UNITED STATES PATENT AND TRADEMARK OFFICE

Office Action Summary

10/539,654

MARIONI, ELIO

Kalb *et al.* also shows the known relationship between the load angle and torque on a synchronous motor. See, for example, figure 4:

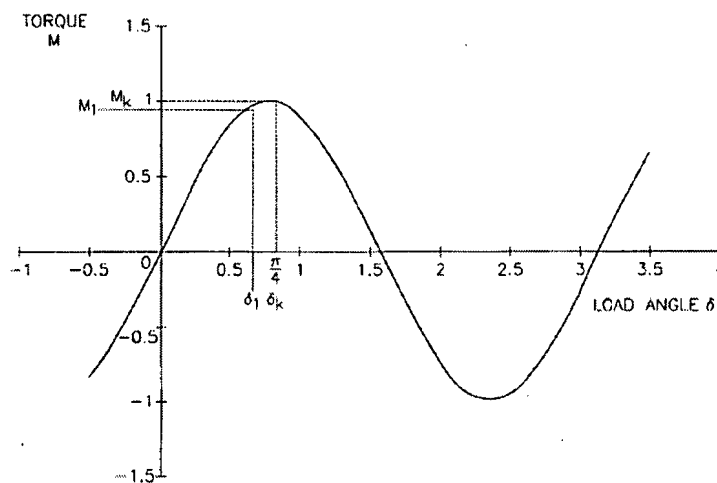
It would have been obvious to one of ordinary skill in the art at the time of the invention to modify the teachings of Kunz with the teachings of Van Cleve *et al.*, the admitted prior art, and Kalb *et al.* in order to indirectly determine the flow rate of the pump by acquiring the phase shift of the motor between the voltage applied to the terminals of the motor and the counter-
